Subject: FW: Penrith Council Comment on Open Space Edge Road - Kemps Creek
Attachments: CO14429.01-PR40-A.pdf

From: Gavin Cherry <gavin.cherry@penrith.city>
Date: Monday, 7 August 2023 at 2:42 pm
To: Christian Kublins <christian.kublins@in-dev.com.au>
Cc: Robert Walker <Robert.Walker@penrith.city>, Stephen Masters <stephen.masters@penrith.city>
Subject: Penrith Council Comment on Open Space Edge Road - Kemps Creek

CONCEPT CIVIL WORKS PLAN-OPEN SPACE EDGE ROAD
1:1000 SCALE

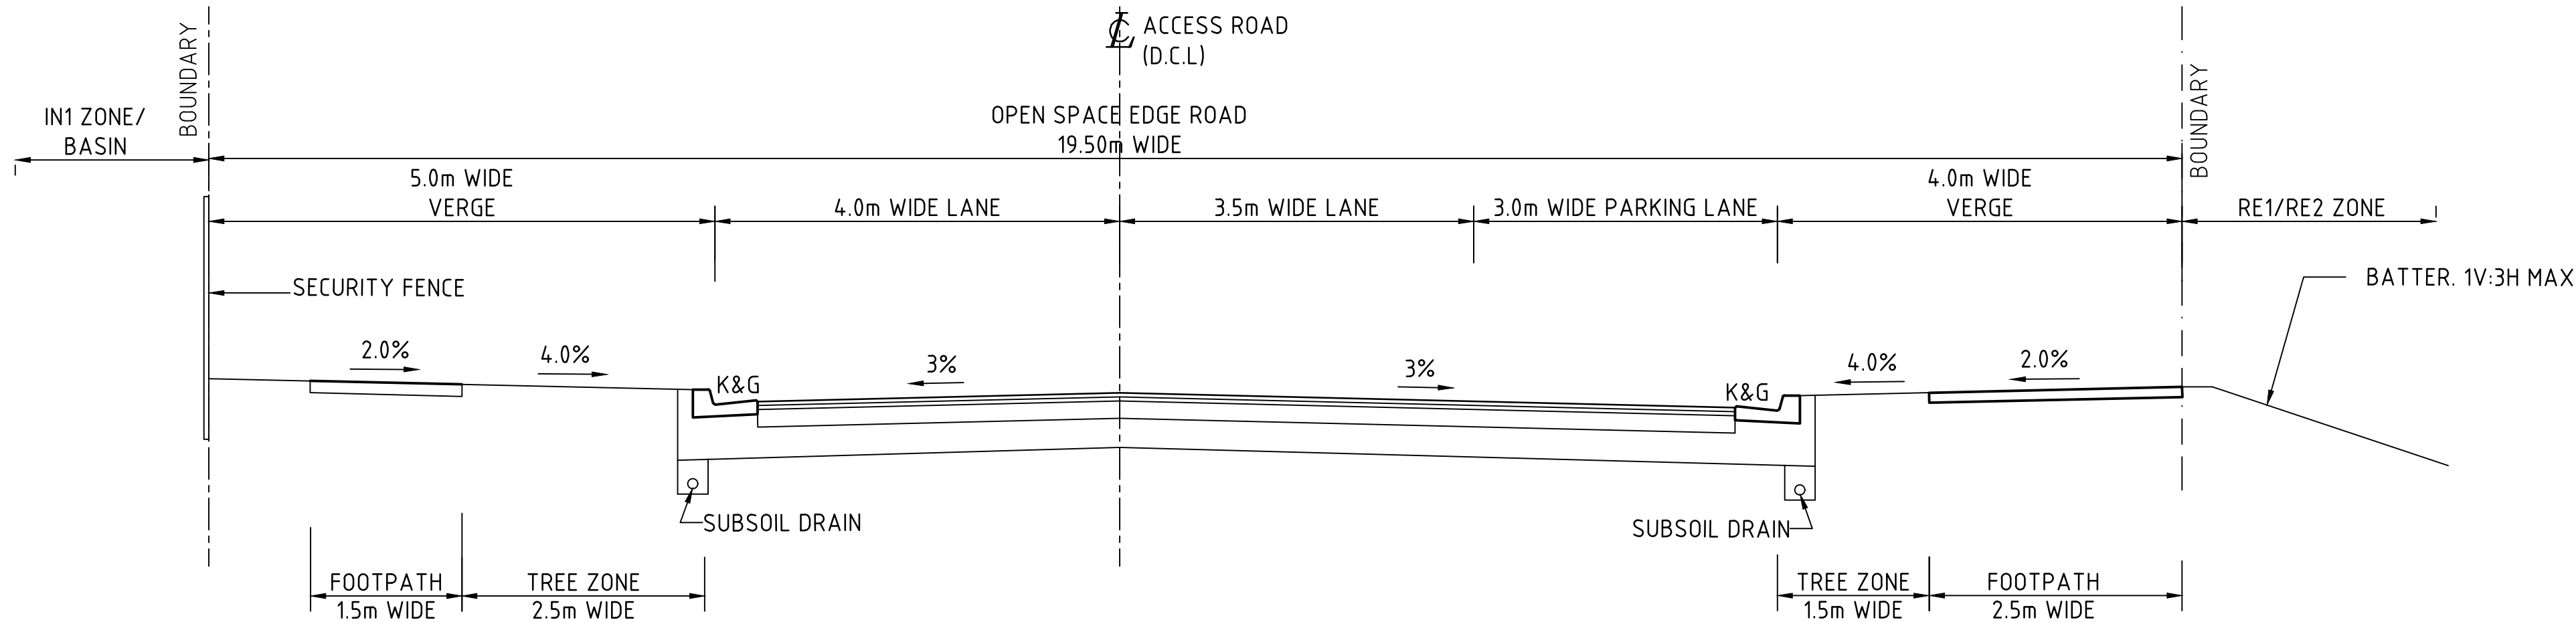
I can confirm that Council does not raise any outright concerns or objections to suggested realignment of the open space edge road to within RE1 zoned land instead of wholly or part contained within Industrial / employment zoned land. A similar position has just been formed and reported to the Sydney Western Sydney Planning Panel for their determination of a DA further north of the subject site. The outcome however is pending.

There are however orderly development considerations that DPE as the consent authority must be satisfied of in the assessment of the proposed realignment. This may also require input from Transport for NSW in addition to Council as Local Road Authority as part of the detailed review phase during public exhibition

The realignment must work north and south noting that this calls into question separate land parcels not subject of the current proposal. Of particular note is the timing of northern connections which extend beyond the attached plan. This may be largely outside the scope of the current proposal, but it would need to be demonstrated that the realignment can functionally work with minimal regrading / earthworks implications for adjacent landowners.

The suitability of the realignment also depends on infrastructure requirements of Sydney Water which need to be ascertained as part of the SSD assessment process. In essence it must be demonstrated that the functional nature of the land as open space is not compromised by the realigned and relocated roadway.

Any intended staging of the SSD development proposal would also inform timing of road delivery and temporary turning head arrangements.
